REMARKS

Drawings

FIG. 1

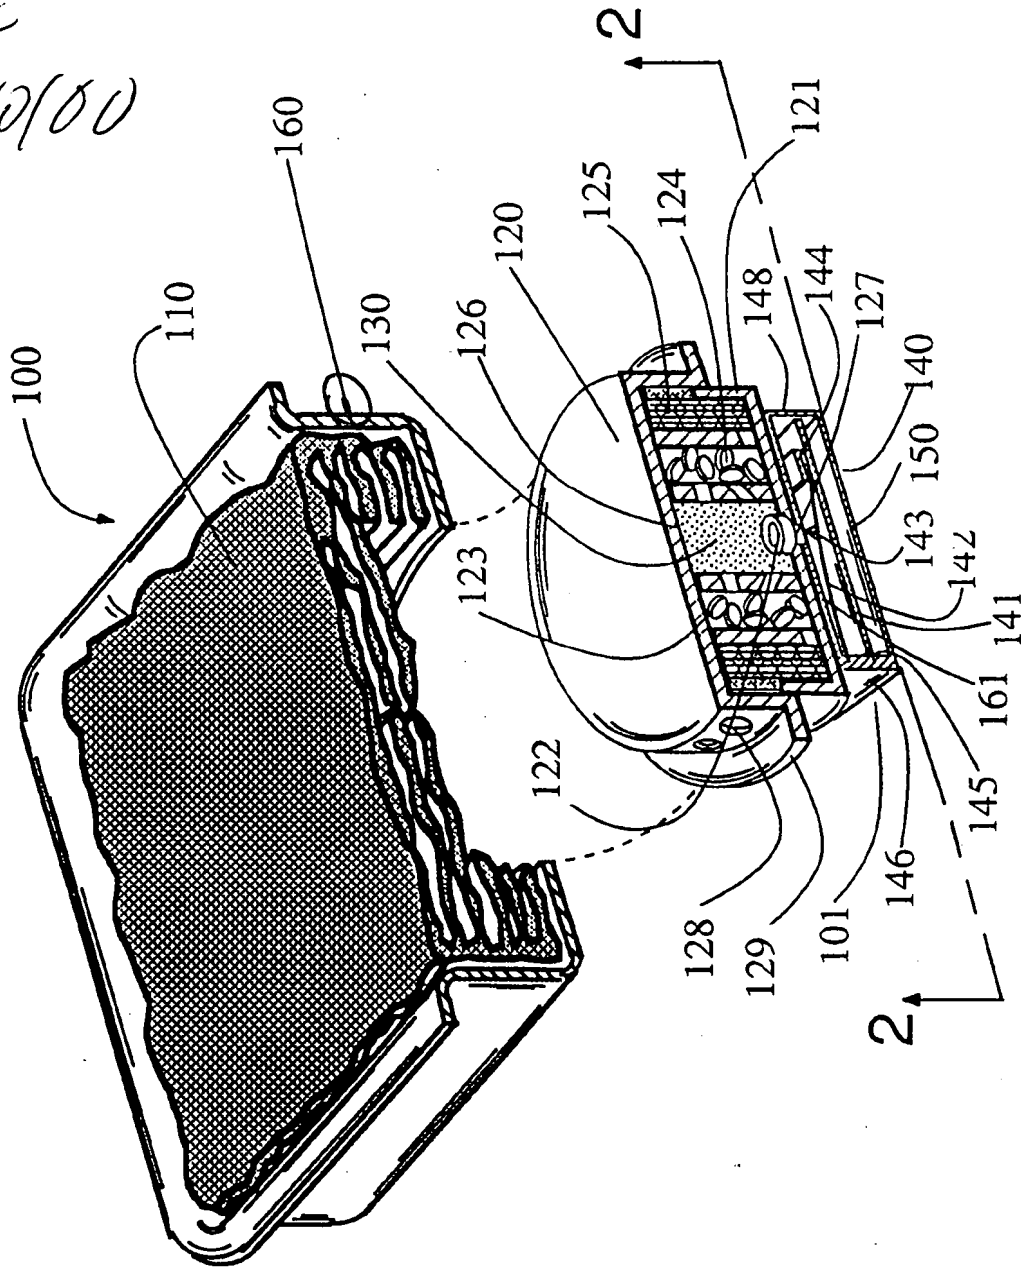
Proposed revised Fig. 1 is submitted herewith in which the lead line for reference numeral 160 touches the plate (the change being marked in red ink).

FIG. 2

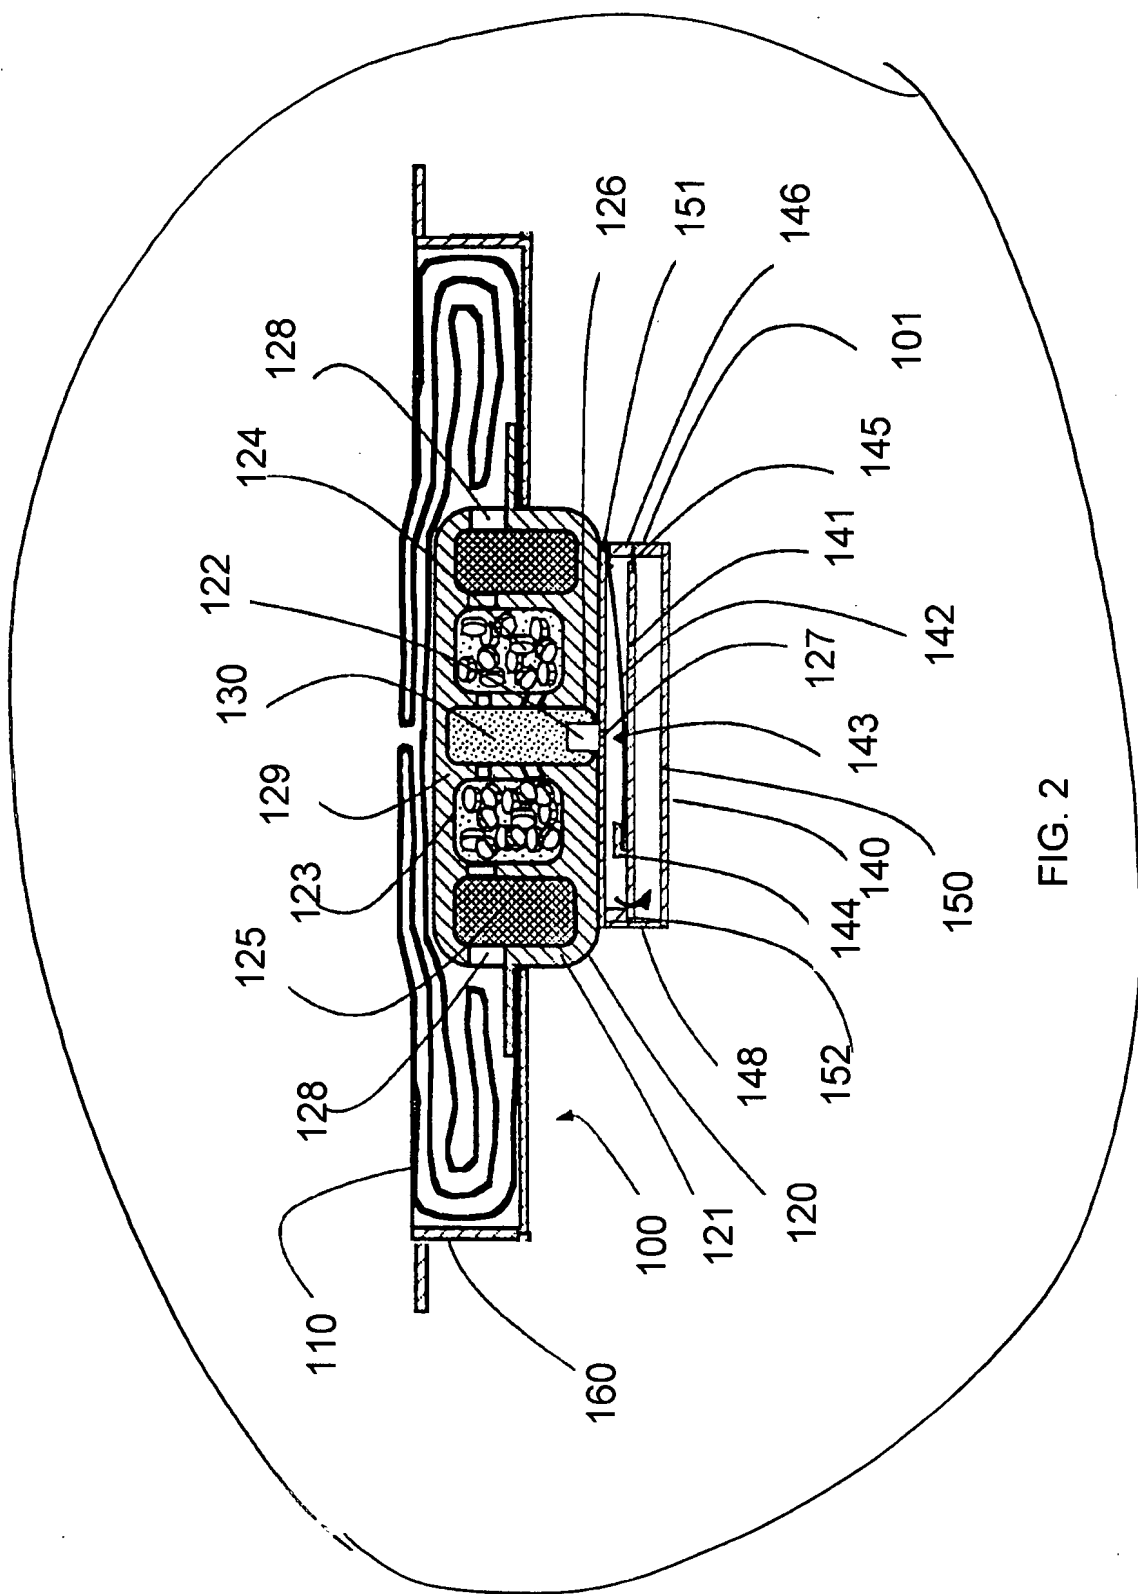
Proposed revised Fig. 2 is submitted herewith in which the designation of the mounting plate has been changed from 130 to 160. Also, the drawing has been inverted to be consistent with Fig. 1. The shape of the plate 160 in Fig. 2 has also been changed to be consistent with the shape of the plate in Fig. 1.

FIG. 9

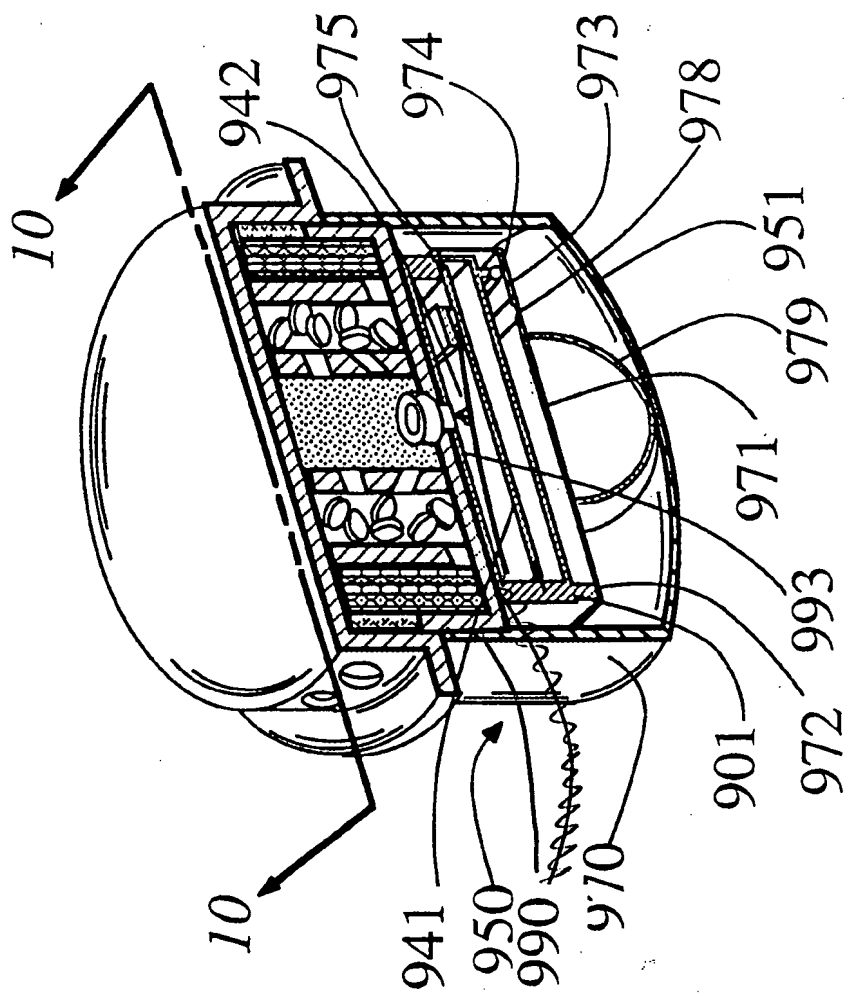
With respect to the description at page 20, lines 3-6, proposed Fig. 9 is submitted herewith in which the lead line from reference numeral 990 has been changed to lead to the area between the sensor can 970 and the housing section of the inflator assembly (the change being marked in red ink).

FIG. 12

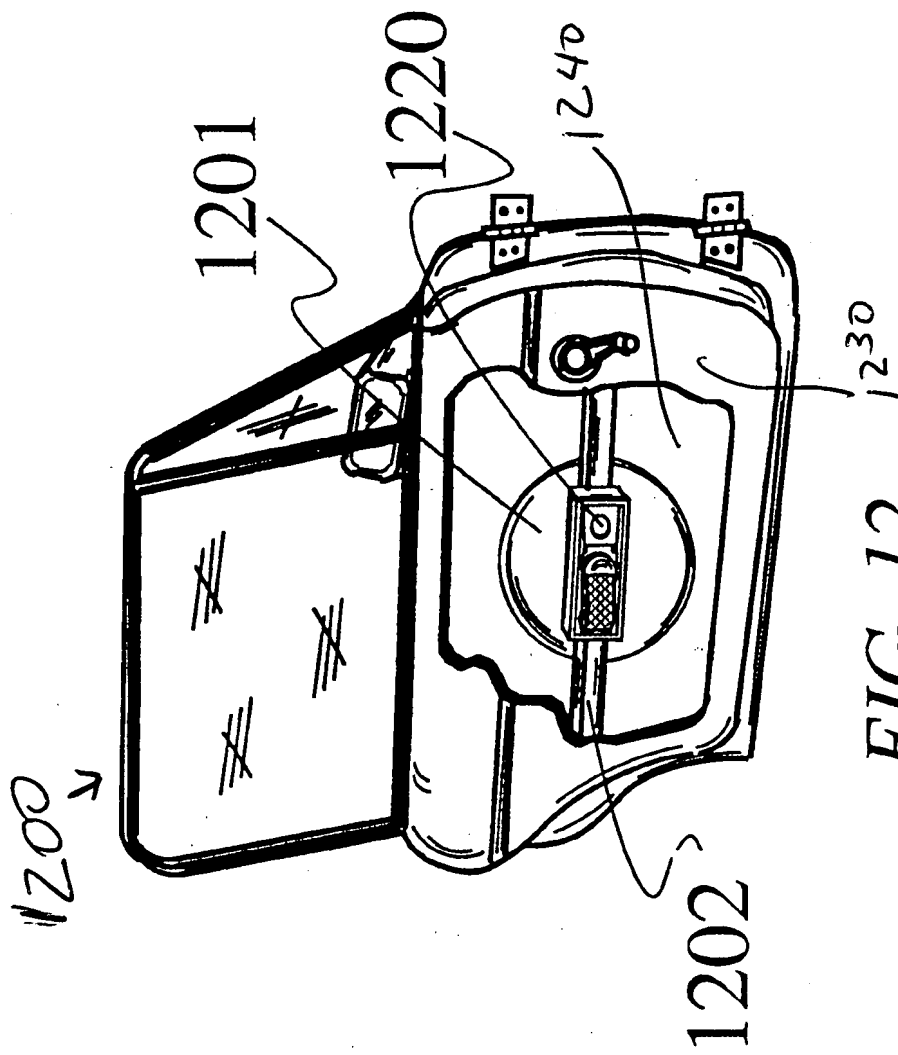
In this regard, it is noted that an embodiment wherein panels are associated with a door is shown in both Fig. 16 (module 1601) and in Fig. 12 (airbag system 1200). The specification has been amended at page 20 to clarify the arrangement of the airbag system 1200 between the inner and outer side panels of the door. Proposed revised Fig. 12 is also submitted herewith with some additional reference numerals.

FIG. 13

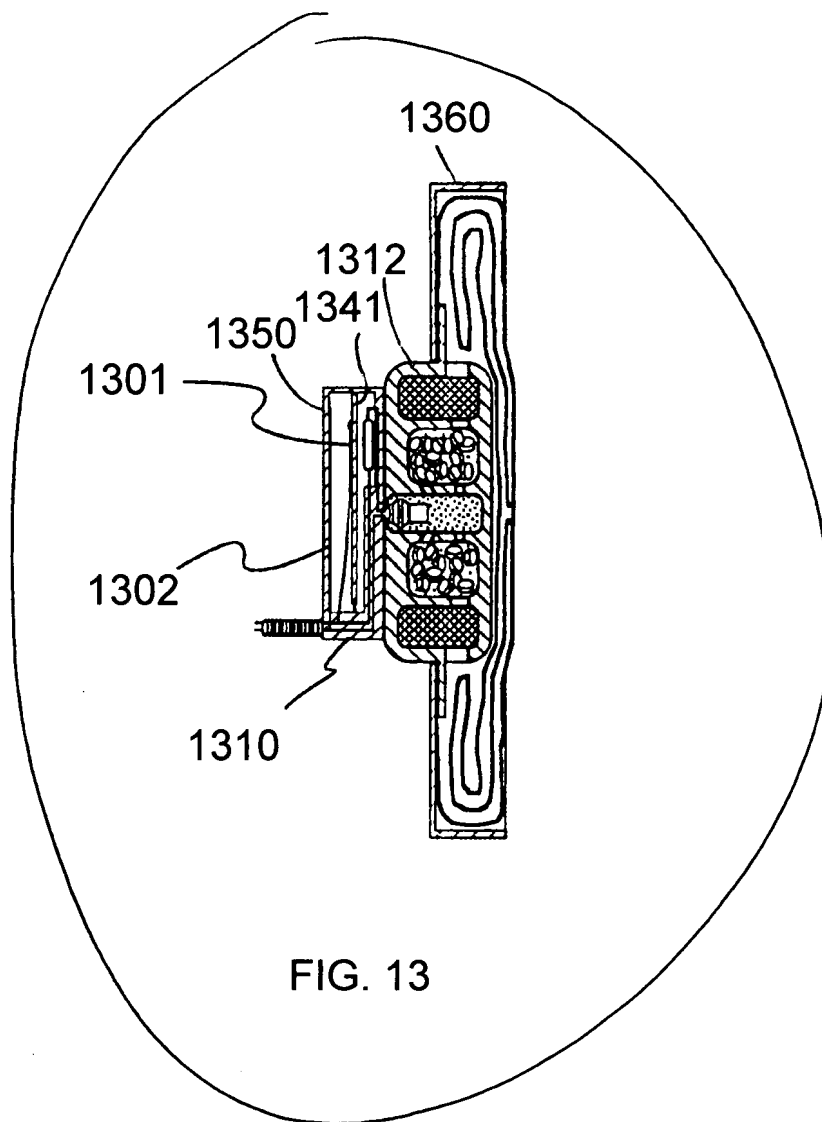
Proposed revised Figs. 13 and 14 are submitted herewith in which the drawings are in the proper orientation, i.e., the airbags face sideward.
